Office Action Summary

09/744,484

GRAFE ET AL.

DETAILED ACTION

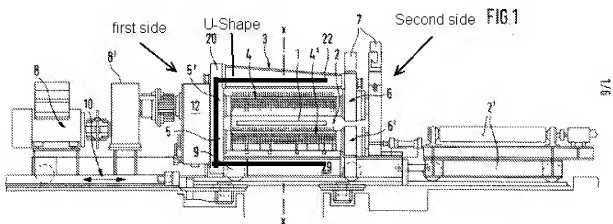
It is unclear what structure of the device (device being the tool as a whole) is the "shears" and what structure is the frame. Shears are labeled as item 3 but item 3 appears to be pointing at arm 22. Also, in the following paragraph the shears include additional structure not typically called shearing structure (i.e. drive apparatus). Using the typical definition of what one skilled in the art would consider shears to be, the shears should only be the cutting blade structure only. So the blade held by the blade holders would be what one skilled in the art would consider the shears. However, the description of Figure 1 in the specification calls the tool in the Figure "shears". Is the tool as a whole to be called "shears"? If this is the case, the preamble should be "A shears device comprising".

On lines 7-8, the phrase "shears arranged on the drive carriage, the shears including a drive apparatus and a U-shaped frame" is unclear. First, "the shears including a drive apparatus" is unclear. Using Figure 1, shears 3 are not remotely close to drive apparatus 8. How can item 8 be considered part of item 3? Next, "the shears 3 appear to be part of the U-shaped frame 20 not the other way around. Especially since shears 3 appears to be on arm 22 of the U-shaped frame. Finally, it would be the frame 20 not the shears 3 that is on the drive carriage 9 since shears 3 do not appear to be in communication with carriage 9.

On lines 8-9, the phrase "the frame having...a removable second side opposite the first side" is unclear. Using the Figure below, the U-shape frame appears to be items 20, 22, and 29. It is unclear what structure makes up the removable second side

of the frame. Basically it is clear what the second side of the frame would be but it is unclear what structure makes the second side removable.

On lines 8 and 10-11, the phrase “the frame having...an upper horizontal arm” is unclear. The frame is first disclosed as being U-shaped. Therefore the frame inherently discloses the structure allowing it to be U-shaped (vertical base and two horizontal arms). Now as claimed, the U-shaped frame has an upper horizontal arm in addition to the inherent U-shaped structure that would give the U-shaped frame 3 horizontal arms making the frame E-shaped.

On lines 11-14, the phrase “the shears further including holding element provided on the first side and the second side of the frame, and blade holders supported by the holding elements” is unclear. How can the holding elements be included as part of the shears structure when the holding elements are provided on the frame? The issue here appears to be what the base structure is. Using the Figure 1, it appears the frame incorporates two horizontal arms making the frame U-shaped; the arms have first

and second sides, holding elements on the first and second sides of the arms, blade holders supported by the holding elements and shears supported by the blade holders.
